## XLamp® XP-C LED Product Change Notification

Customer Name: XPC White, Blue LED Customers    PCN Reference Number: CreeLED-PCN-5313  
 Date Issued: May 16, 2022

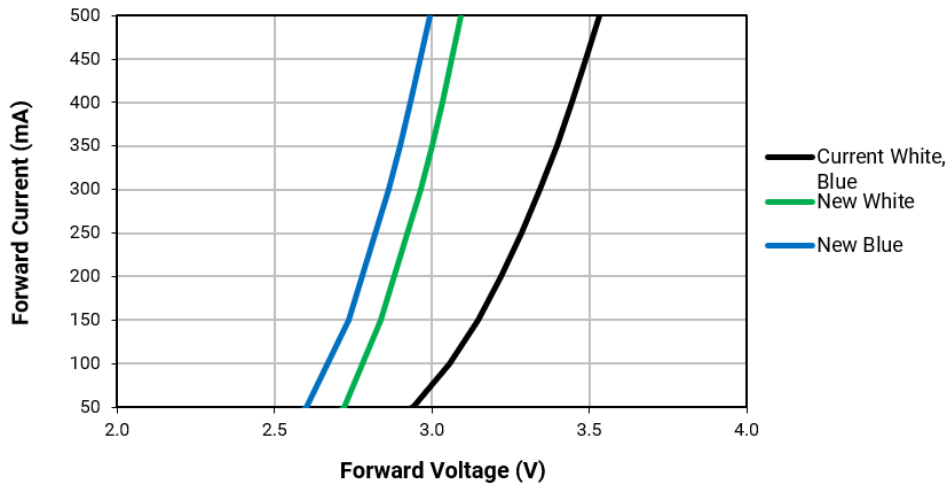
Cree LED will be changing the typical thermal resistance, typical and maximum forward voltage, and typical temperature coefficient of voltage characteristics for the affected XP-C LEDs. Table 2 shows the current and new values.

The following graph shows the improved Forward Voltage vs Current curves.
